Village of Anmore

Date: February 3, 2026 **File No:** 3360-20
Re: Pinnacle Ridge Referral Responses
From: Mayor John McEwen

Date: November 28, 2025 File No: 6410-01
 Submitted by: Josh Joseph, Village Planner
 Subject: Pinnacle Ridge Referral Summary

Re: Response to Referral - Anmore Zoning Amendment Referral - Pinnacle Ridge Hillside Development - Zoning Amendment Bylaw No. 699-2024

Figure 2: Lidar watershed and stream analysis, combined site approximate area marked-up.

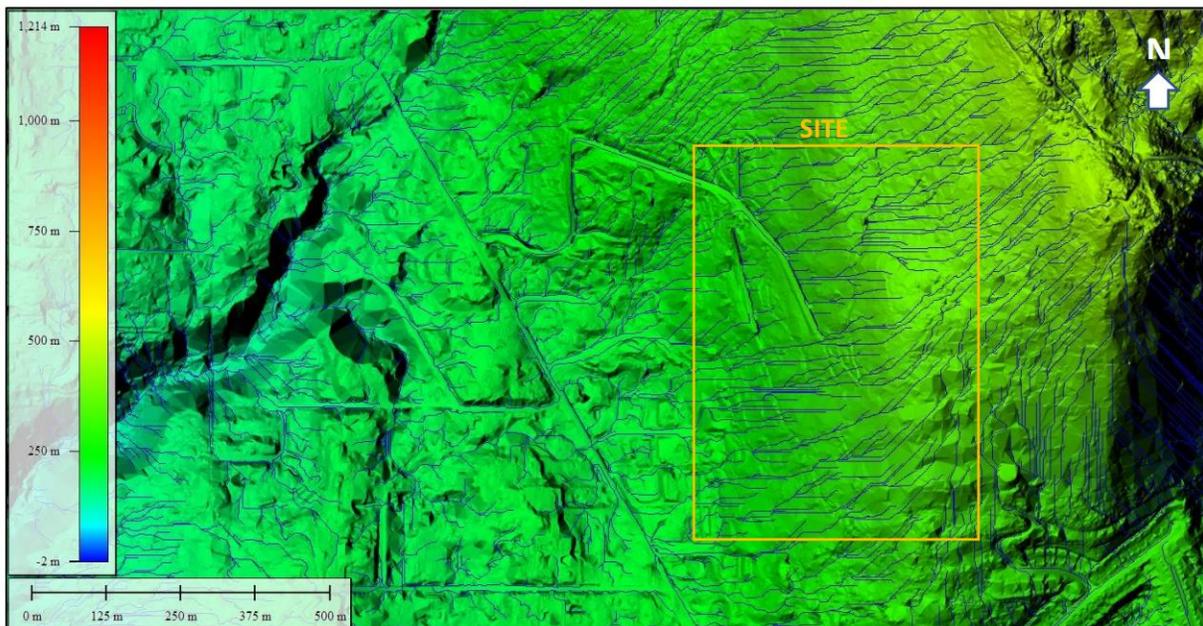
- 1.4. These changes raise concerns about habitat disruption and long-term ecological effects. Environmental assessments submitted to date are limited to the boundaries of the subject properties and do not evaluate potential impacts on adjacent City lands. It's noted that LiDAR mapping from the geotechnical reports identifies numerous watercourses on City Park property which may be impacted by either the adjacent development or the emergency access road. An environmental overview and impact assessment is necessary to determine the presence of unmapped streams, species at risk, or other sensitive ecosystem components that may be affected by the development.
